Measure C Bond Office

Subject: Addendum 2, Bid FB-25-02, Camarillo Heights STEM Academy, Campus
Fire Alarm Upgrades

Project: PVSD Camarillo Heights Elementary School 03-124308
Subject: Narrative for CCD-001 delta 1 regarding electrical changes to Contract Documents

E690

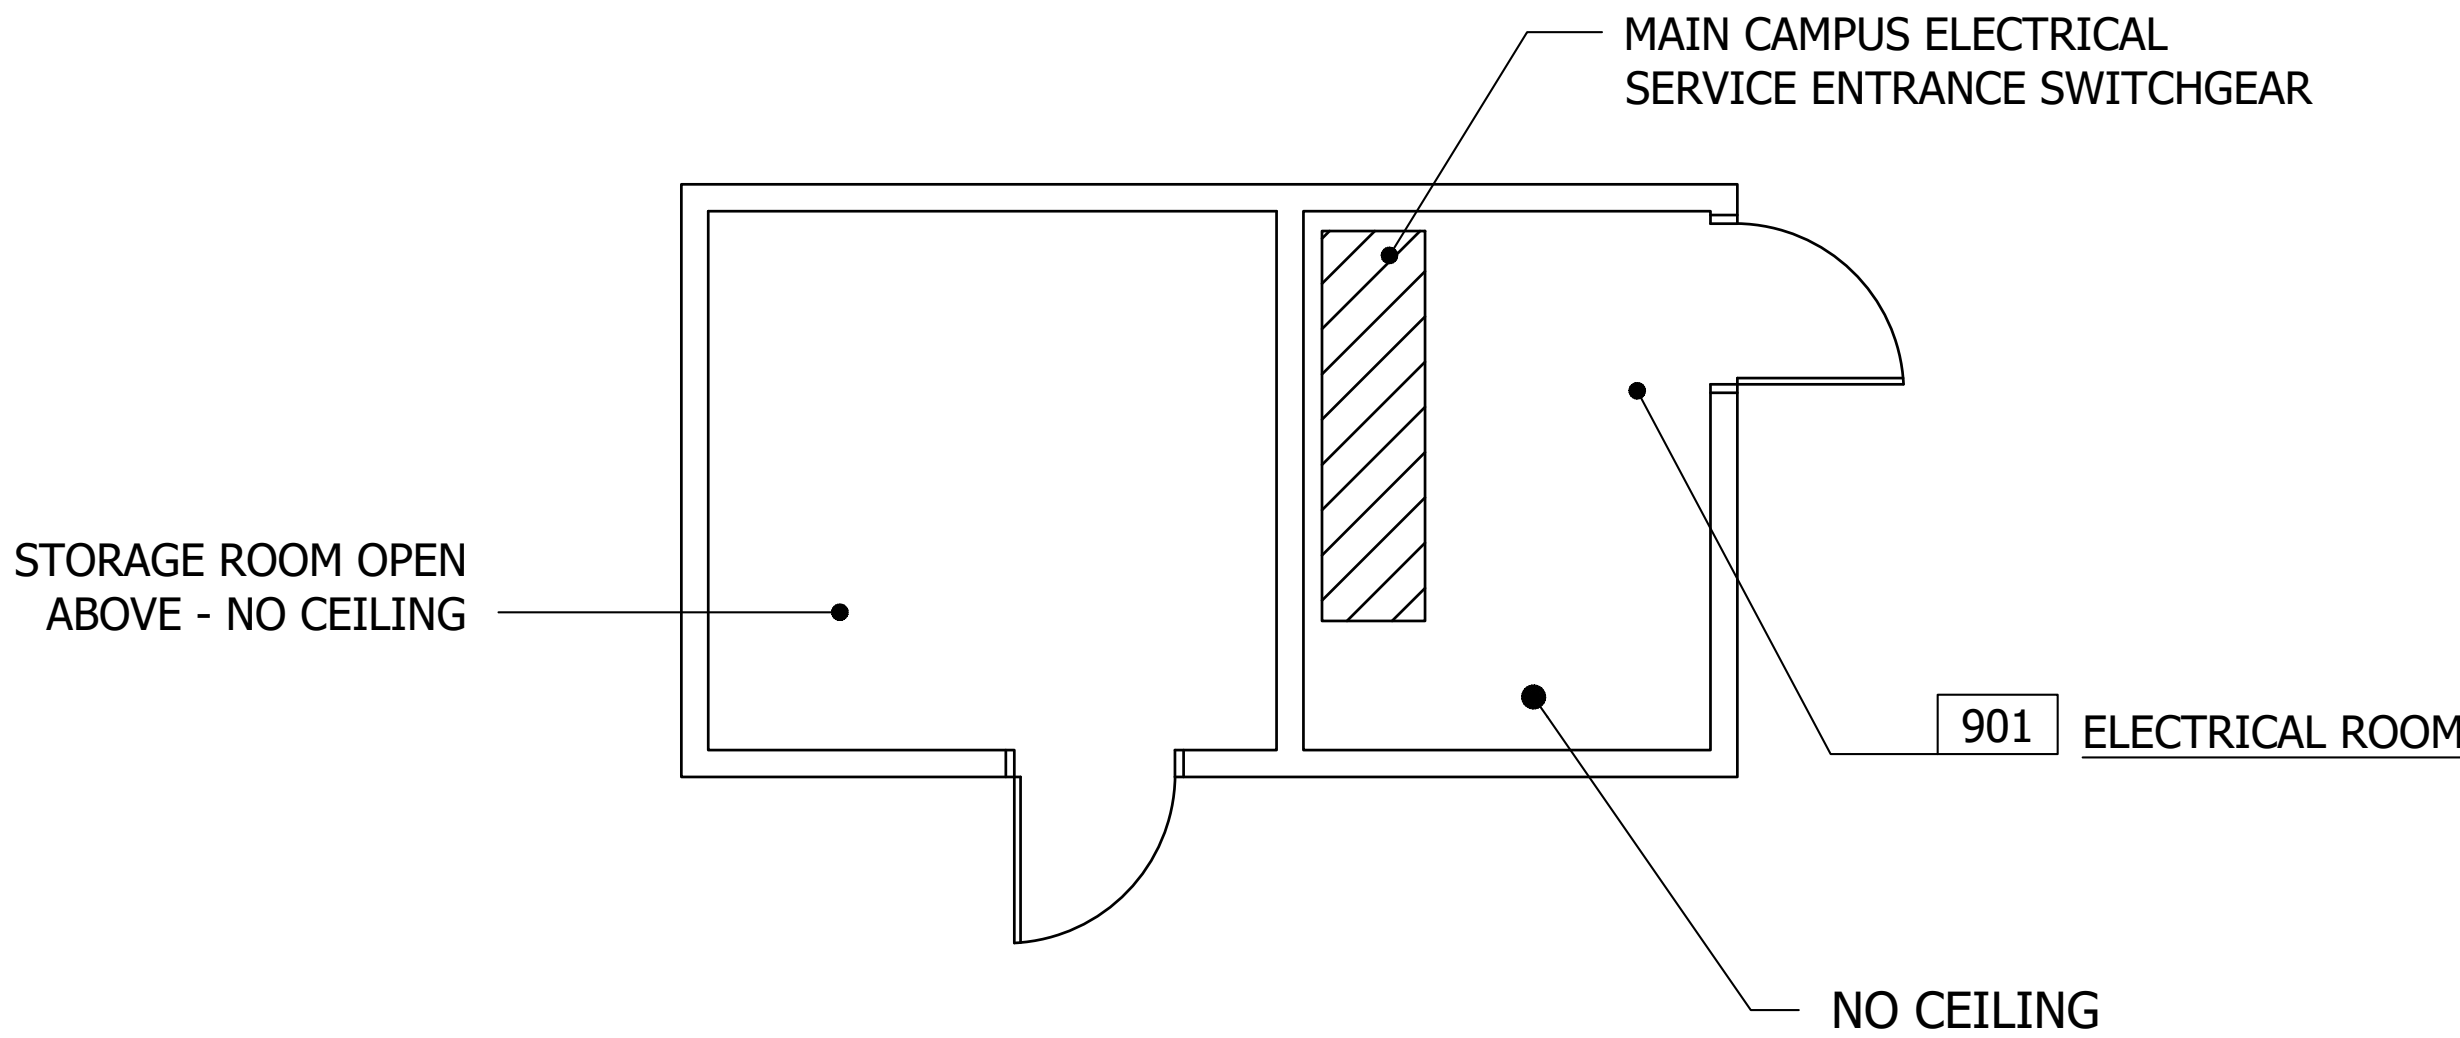
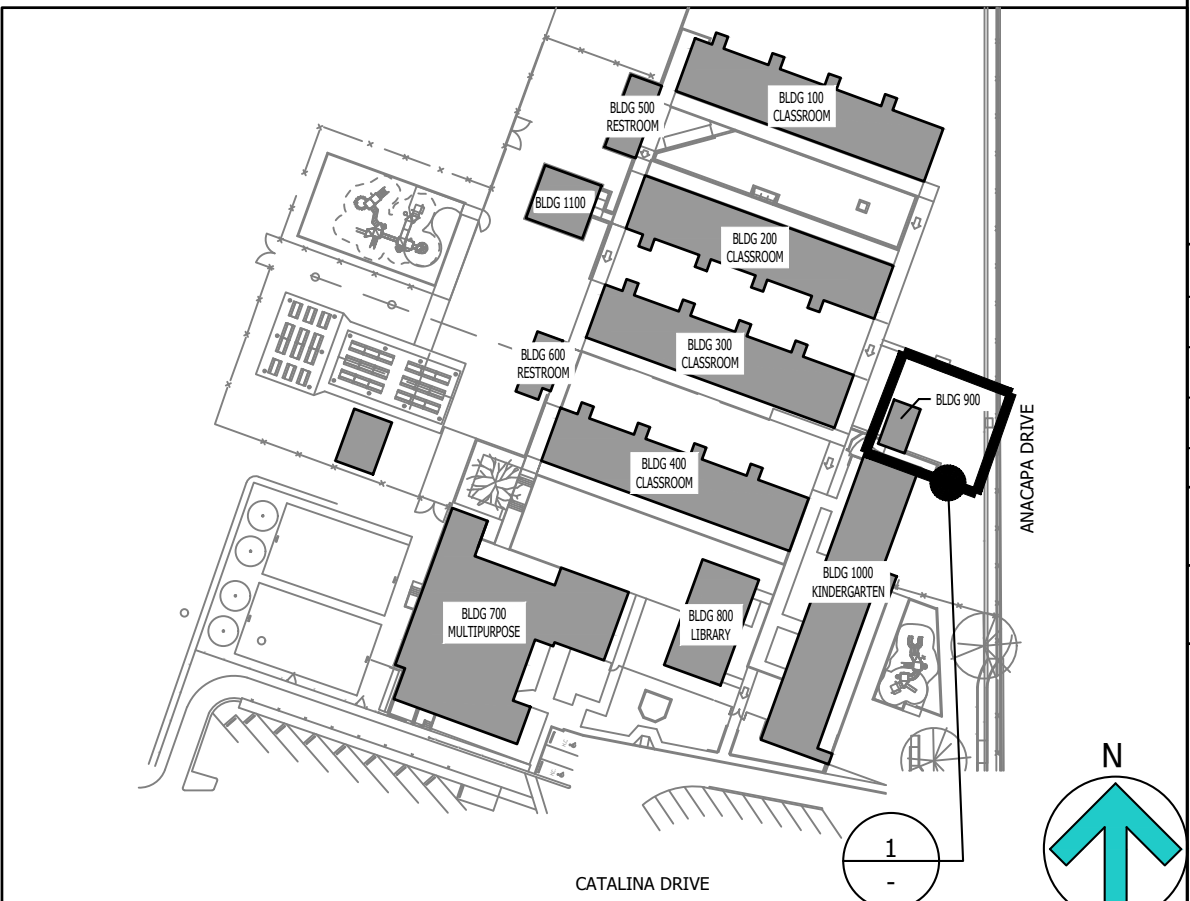
- Changed smoke detectors so only one CO (Carbon Monoxide) detector is needed in each room, the remaining detectors will be the Silent Knight IDF-PHOTO-W.

PROVIDE ONLY ONE CO DETECTOR (SILENT KNIGHT IDF-FIRE-CO-W) IN EACH CLASSROOM, THE REMAINING DETECTORS SHALL BE SIELENT KNIGHT IDF-PHOTO-W (PHOTO IONIZATION (TYPICAL)

E700

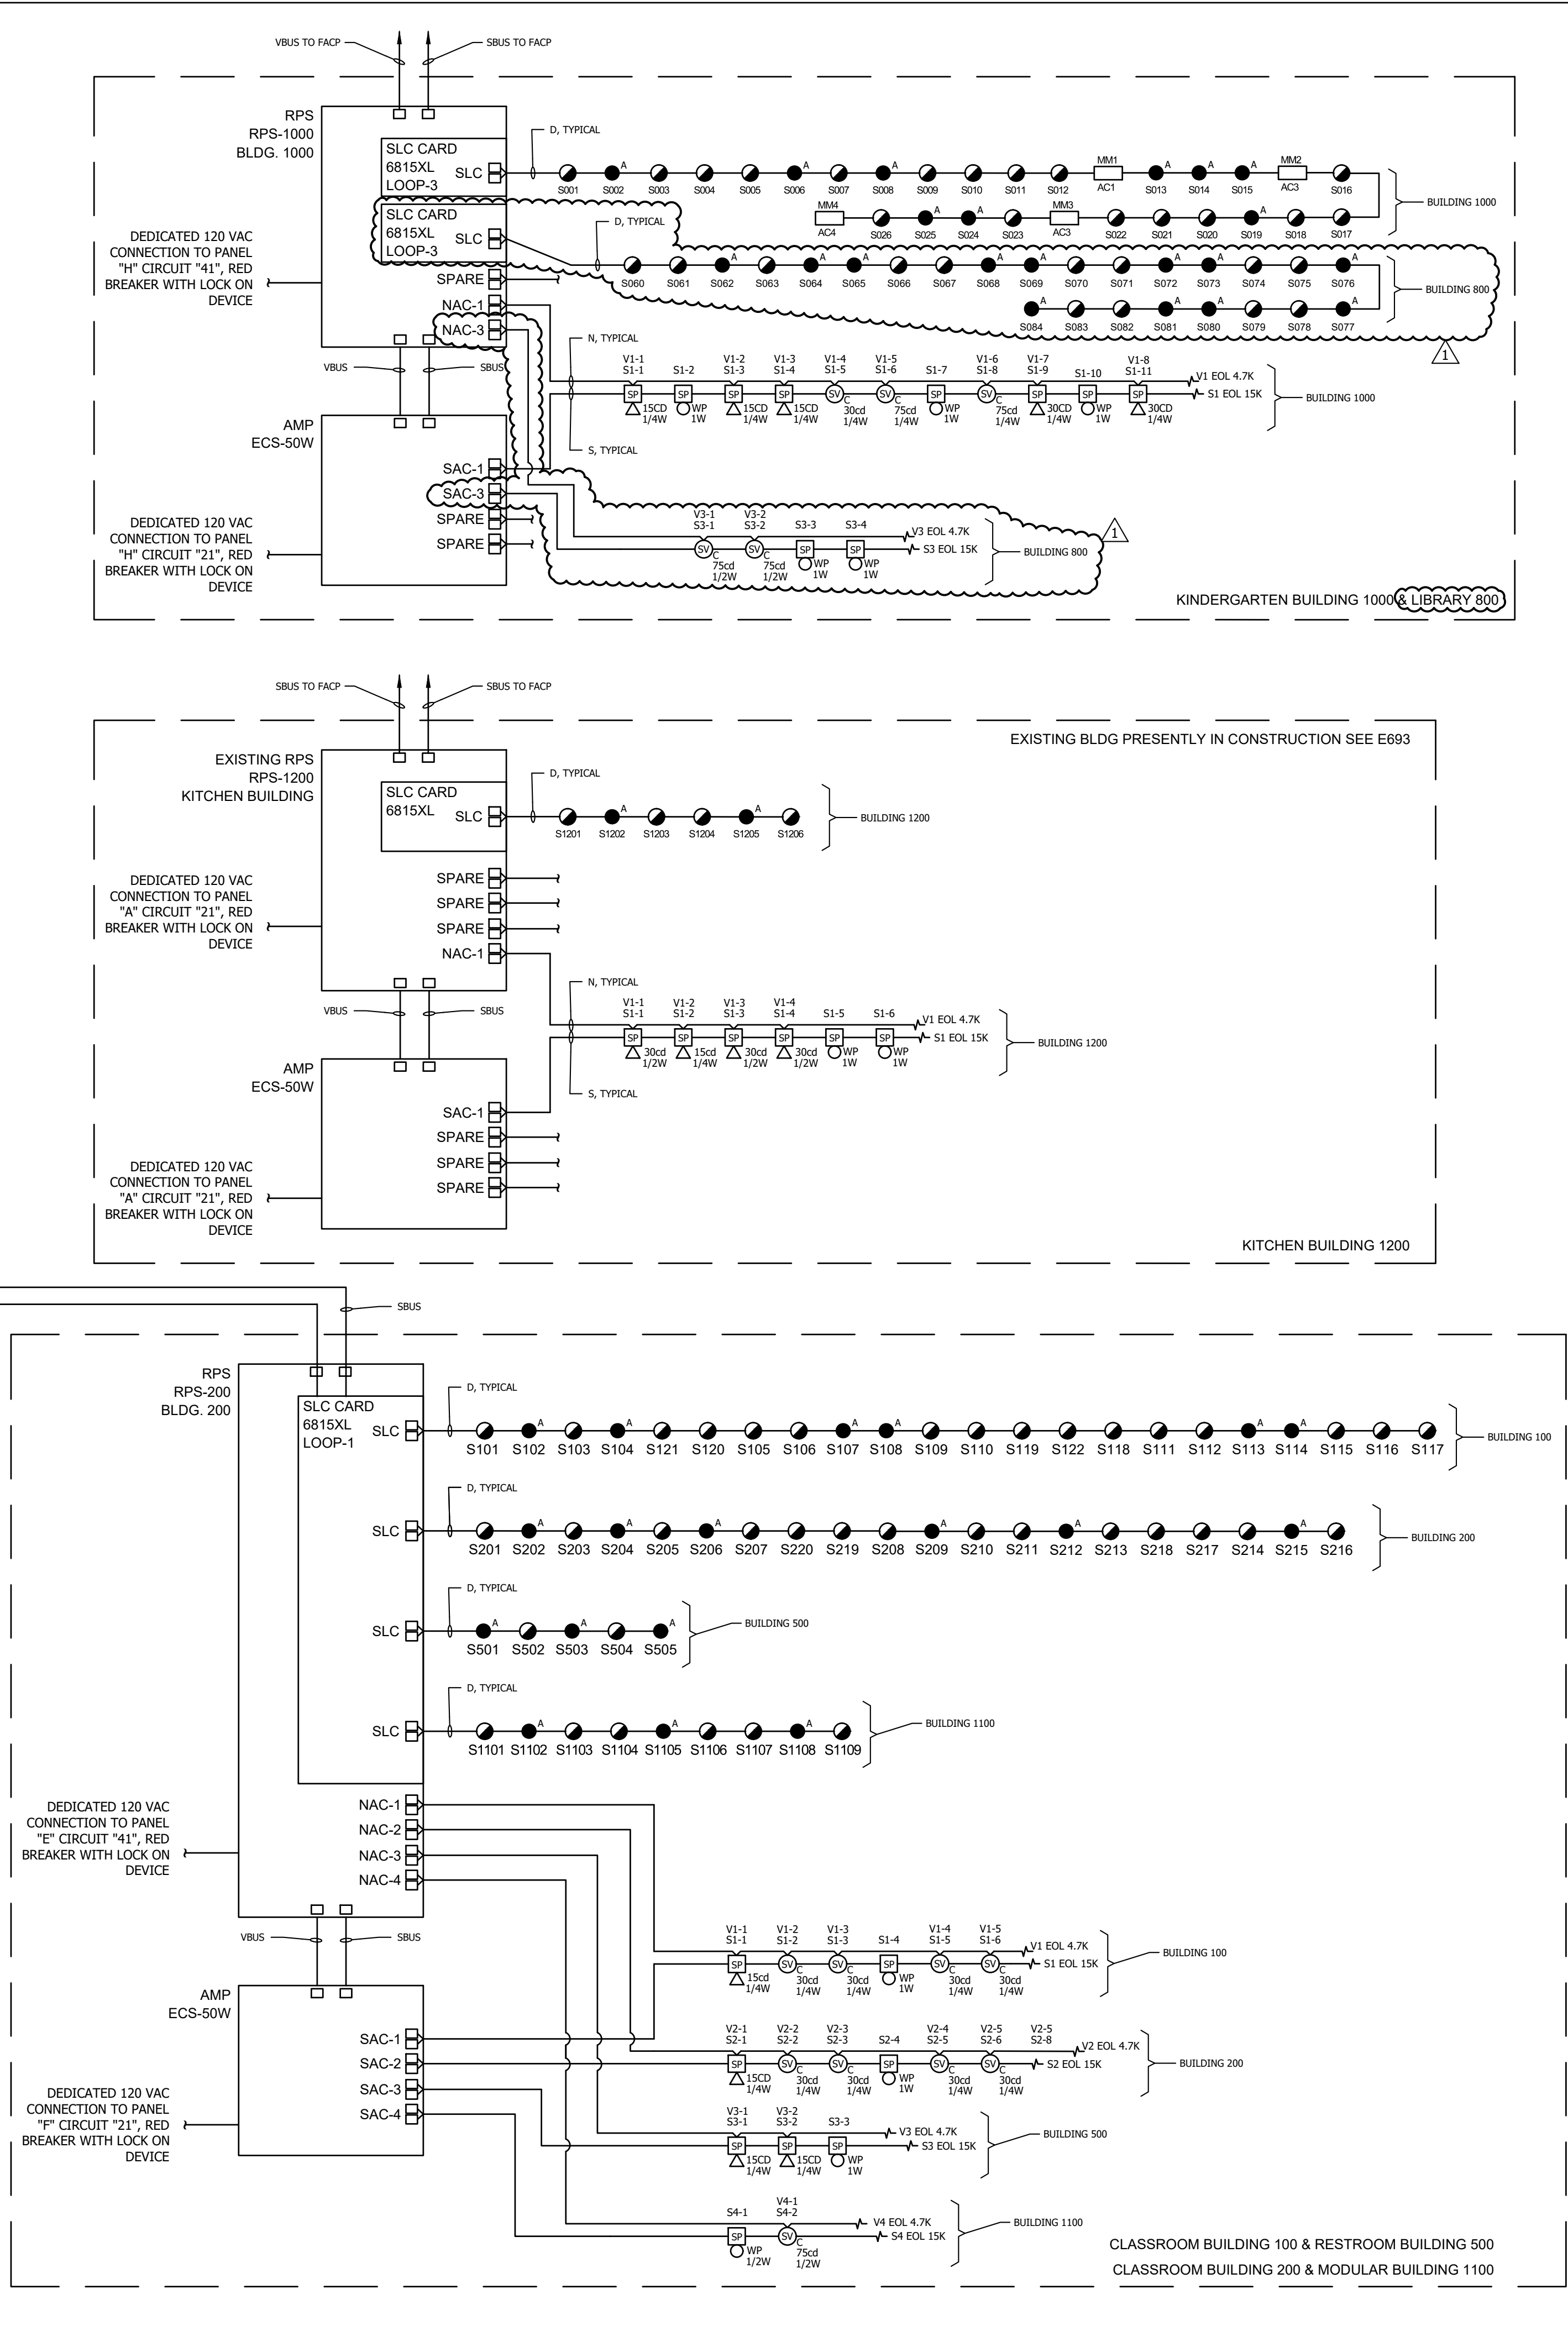
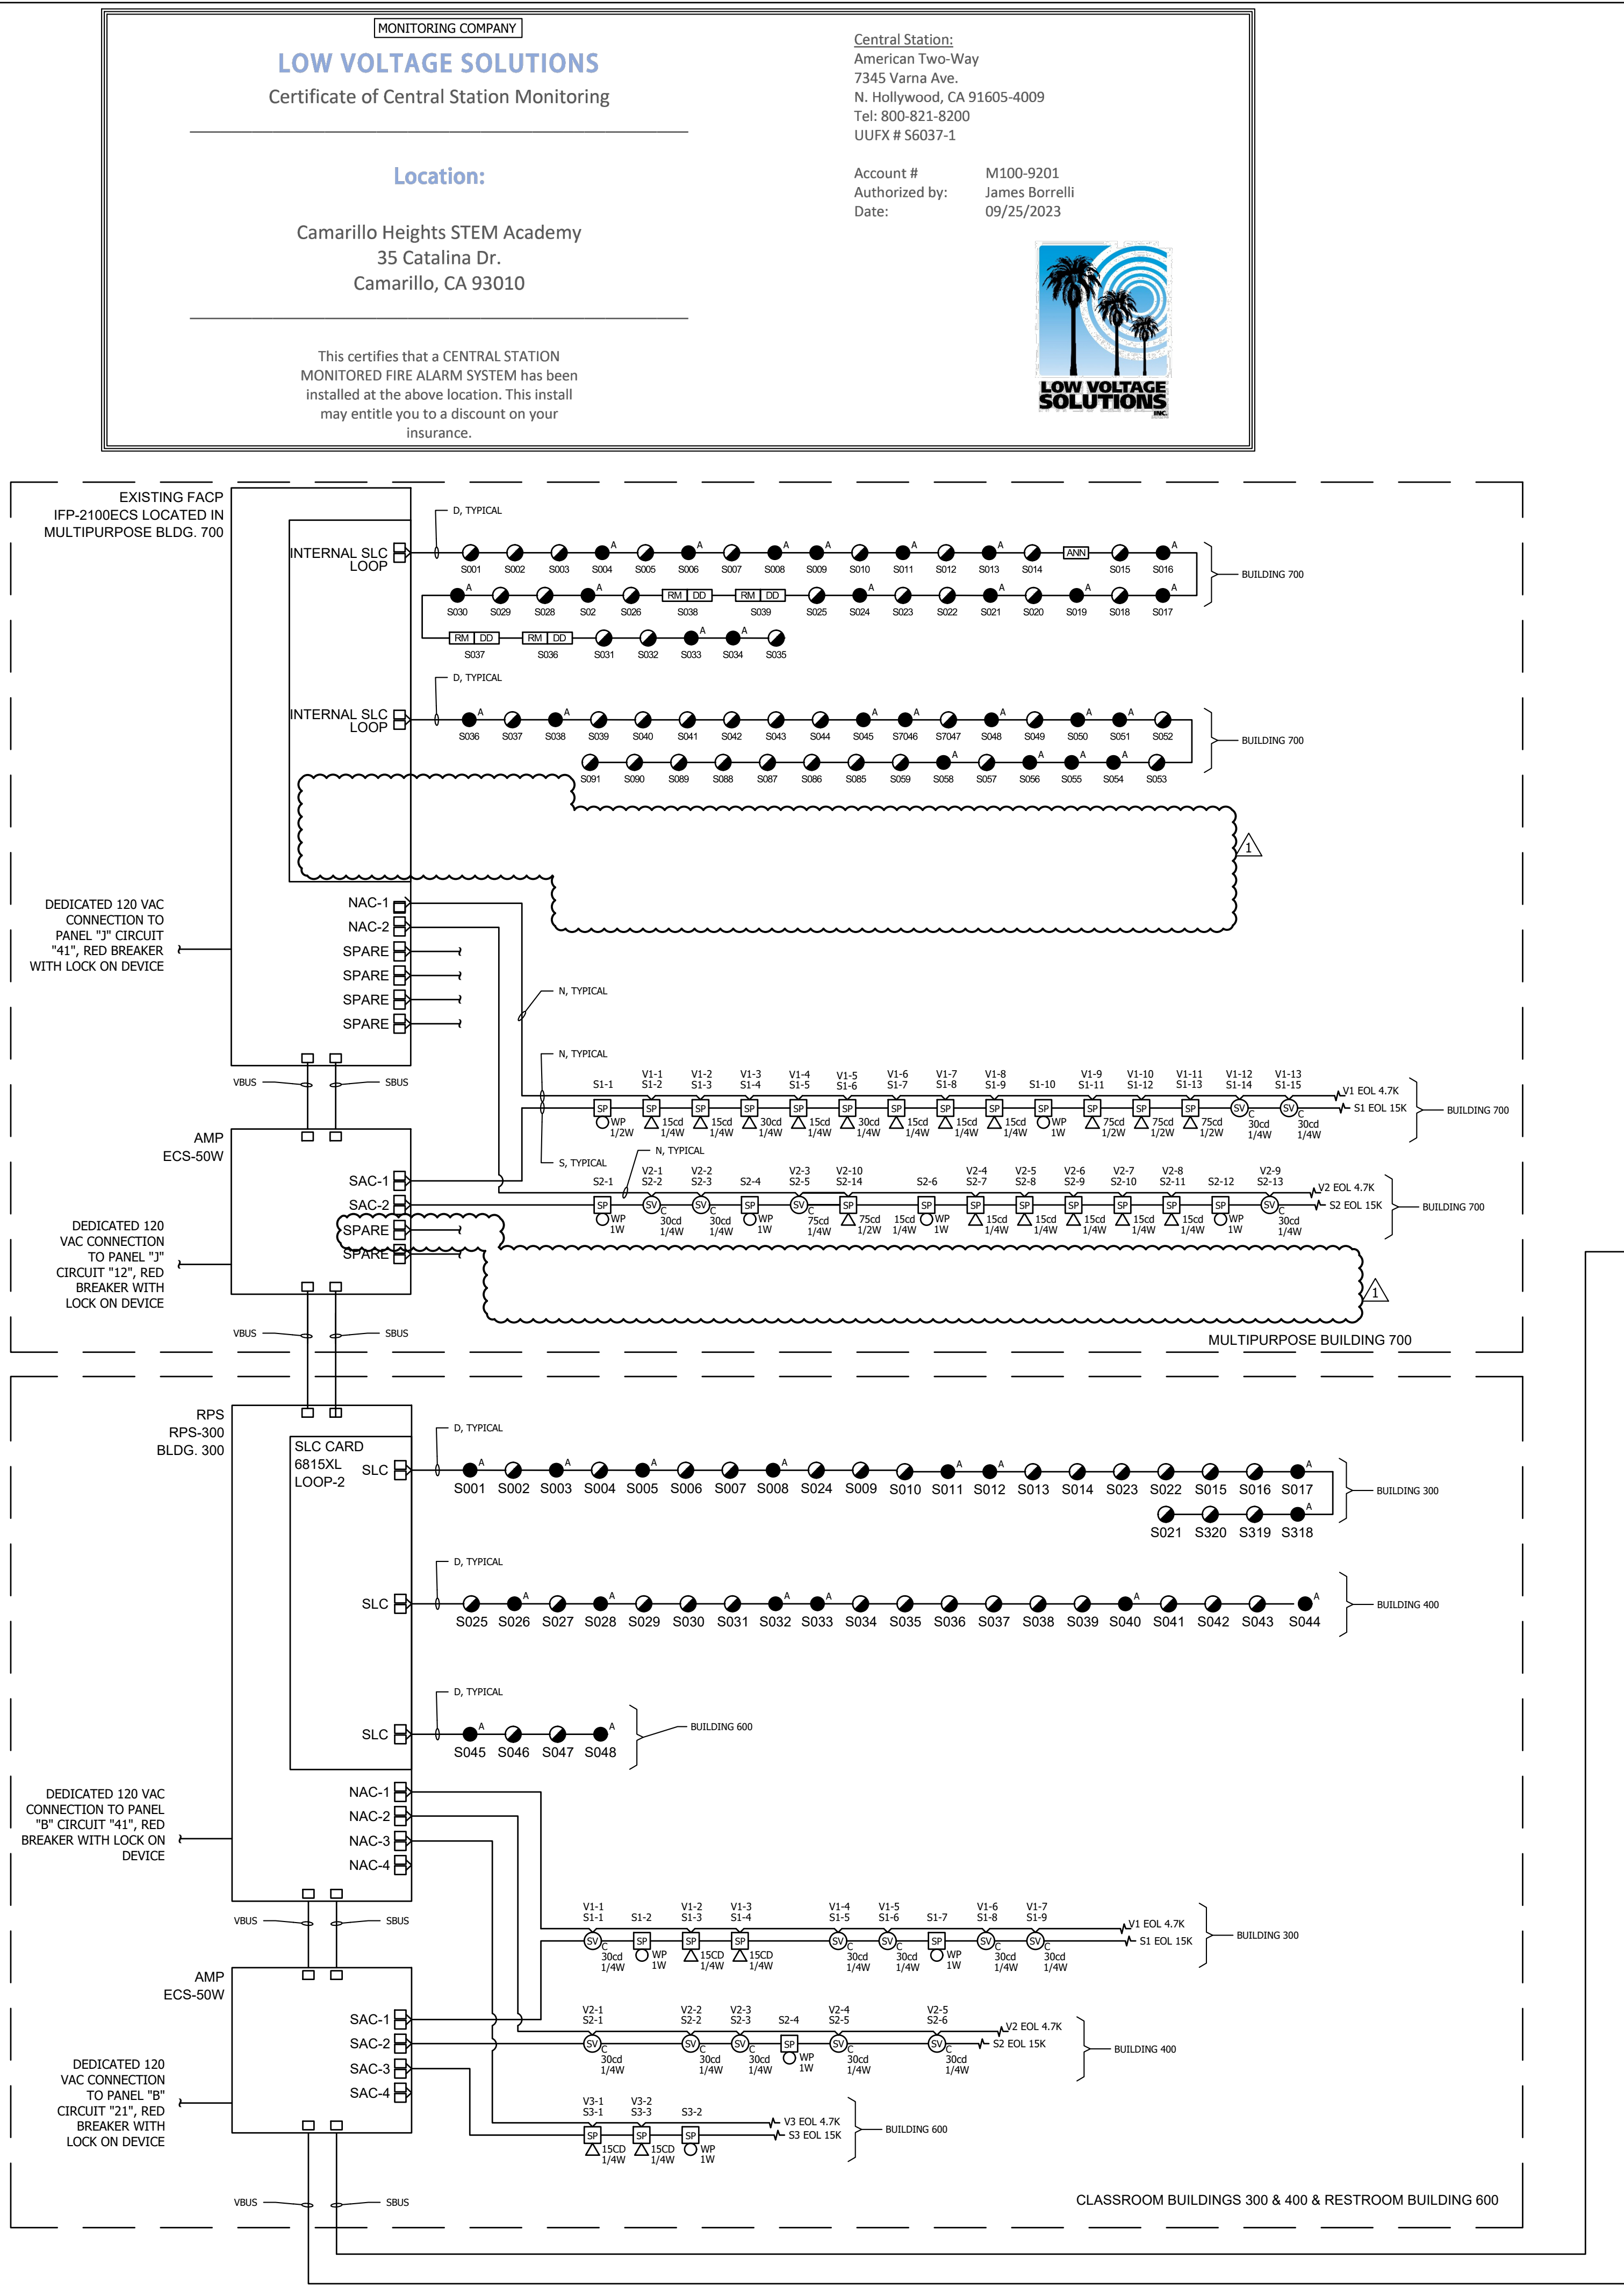
- Added key note 7 to all FSD devices
- Moved the SLC, SAC, & NAC loops for Building 800 to be connected to Building 1000 'Kindergarten' RPS
